MODELS AFFECTED
1948-50 LAND-ROVER

DUST-PROOFING

Modifications have been introduced to seal the engine unit against the entry of dust; if necessary such modifications can be incorporated on earlier vehicles by following these instructions.

Fig. 1. Piston modification

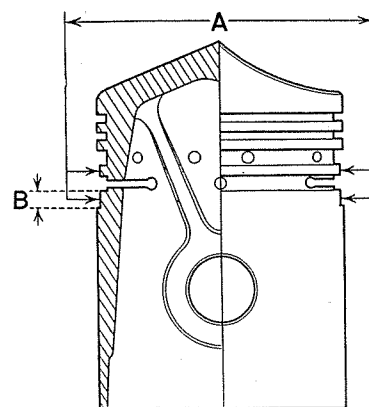
Remove the pistons and modify them by reducing the bottom land and top of the skirt as shown at Fig. 1.

A—Reduce diameter to 2.676 in.—.004 (68 mm.—0,10) for "60" and Land-Rover or 2.506 in.—.004(63, 6mm.—0,10) for "75".

B— $\frac{3}{16}$ in. (4,8 mm.)

Fig. 1 Modification to sparking plug cover.

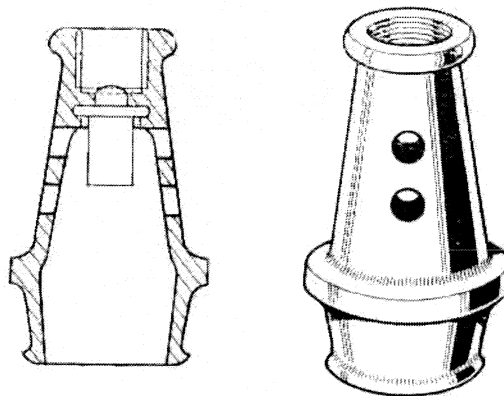
- REMEDY.
1. Remove the sparking plug covers and dry thoroughly.
 2. Drill four $\frac{3}{16}$ in. (4,8 mm.) holes in the cover as shown at Fig. 1. The lower holes

are drilled on the same centre line as the existing $\frac{1}{8}$ in. (1,6 mm.) ventilation hole; the upper holes should be positioned at $\frac{3}{8}$ in. (9,5 mm.) centres above the first holes.

3. Remove, clean and dry the sparking plugs; re-set the gaps as necessary and replace.
4. Replace the covers with the holes lying to front and rear, *i.e.*, with the holes parallel to the engine centre-line. In this way the air flow assists in evaporation of any condensation.

Fig. 1. Door gusset plate.

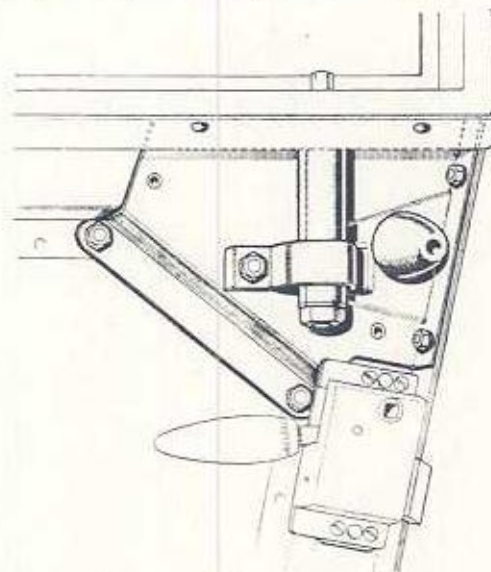
1. Remove the side screen.
2. Remove the door from the vehicle.
3. Remove the upper buffer from the door.
4. Shear the two rearmost rivets securing the top capping.
5. Secure the free end of the clip to the gusset plate by means of the bolt and plate, spring and plain washers and nut provided.
6. Fit the gusset plate in position as shown at Fig. 1.

7. Drill two $\frac{1}{4}$ in. (6.5 mm.) clearance holes in the door panel and secure the plate by means of the two $\frac{1}{4}$ in. bolts, spring washers and nuts provided.
8. Drill the plate through the rivet holes in the top capping and secure the capping and plate, using two new rivets.

9. Drill two holes in the door shut flange, using the gusset plate as a guide and secure with the two 2 B.A. screws, spring washers and nuts provided; the screw heads should be on the outside of the door.
10. Secure the plate to the door reinforcement by means of the two pop rivets provided.
11. Tighten the clip against the side screen fixing tube by means of the nut fitted at Operation 5.
12. Replace the rubber buffer.
13. Replace the door and sidescreen.
14. Repeat Operations 1—13 for the other door.

Fig. 1. Dust-proofing doors.

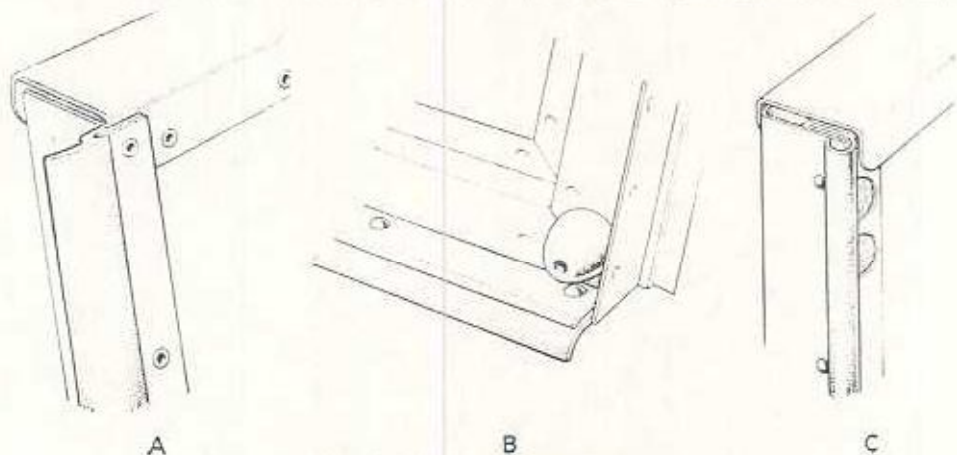
Modifications have been introduced to seal the doors and tailboard against the entry of dust, on all vehicles numbered 06101747 onwards; if necessary, such modifications can be incorporated on earlier vehicles by following these instructions.

1. Remove the door from the vehicle.
2. Fit retainer (301413 or 301414) into weather strip (301411).
3. Clamp the retainer and strip to the rear edge of the door with the rubber overhanging 1 in. (25 mm.) as shown at Fig. 1 A.
4. Using the retainer as a guide, drill the six 3/16 in. (4.8 mm.) holes through the rubber and door panel; secure the retainer with six pop rivets (300781).
5. Position weather strip (301893) along the inside bottom flange of the door with 1 in. (25 mm.) overhang.
6. Place retainer (301415) over the strip with its radiused edge overhanging the door edge (Fig. 1B).

Fig. 2. Dust-proofing tailboard.

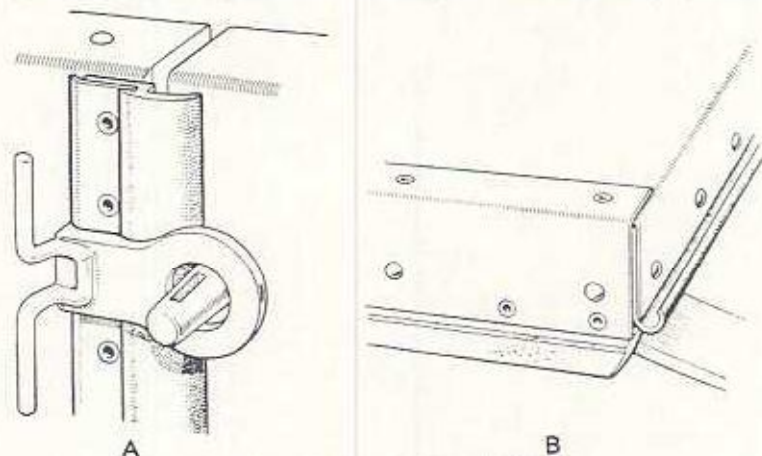
1. Remove the tailboard from the vehicle.
2. Remove the hinges from the tailboard.
3. Fit short, upper side retainer (301870 or 301418) into weather strip (301432). See Fig. 2A.
